# LONG ACRES ENVIRONMENTAL STATEMENT

VOLUME 3: TECHNICAL APPENDICES  
APPENDICES TO CHAPTER E  
(NOISE AND VIBRATION)

# **Long Acres, South Tees**

# **Appendix E1: Consultation Correspondence**

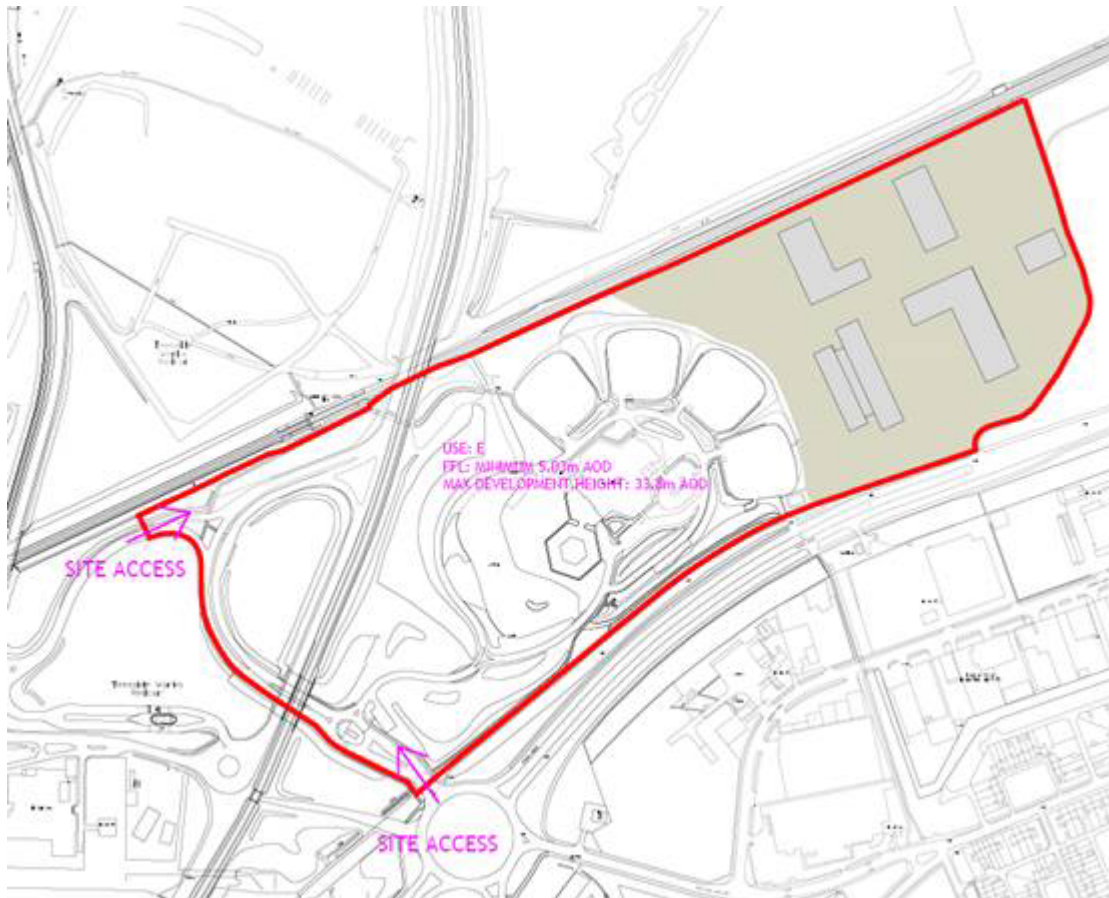
We have daily update on this proposal. Attached image below shows the existing office building and the proposed buildings on the eastern side of the site boundary.

It is our understanding that the area shown below in grey is the actual development locations, although the site boundary does include the existing office building.

This application is for new office buildings. Does this change your response? As I thought, there may have been bit of misunderstanding of the application.

my only comment is that you should assume any plant will be facing the nearest NSR from the new development.  
regards

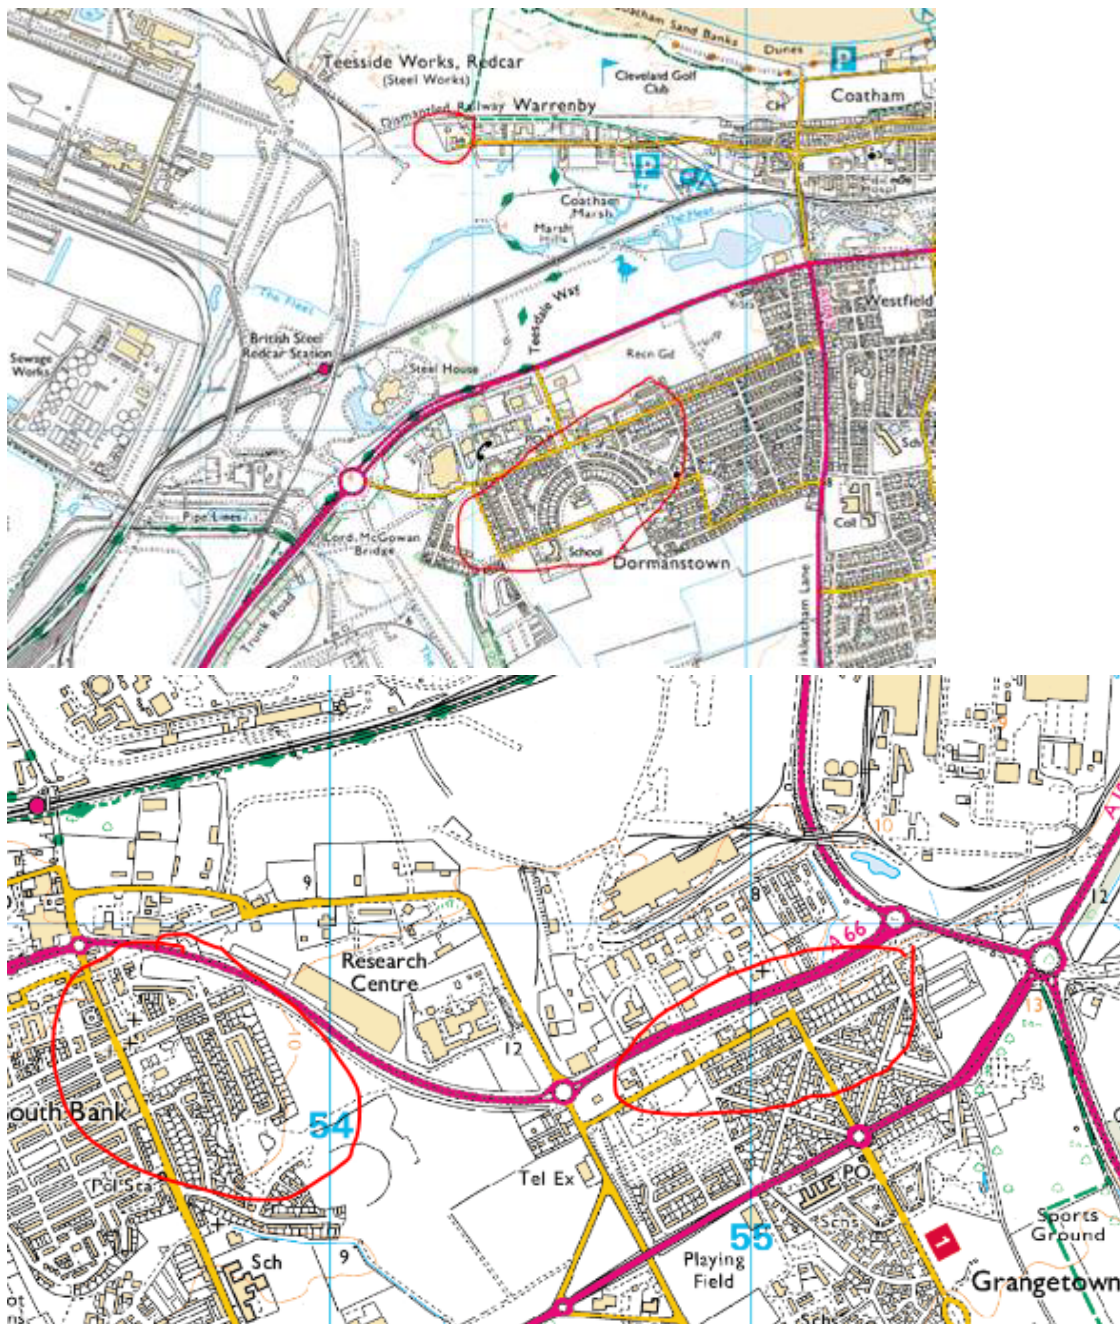
Highlighted closest residential properties circled in red below.
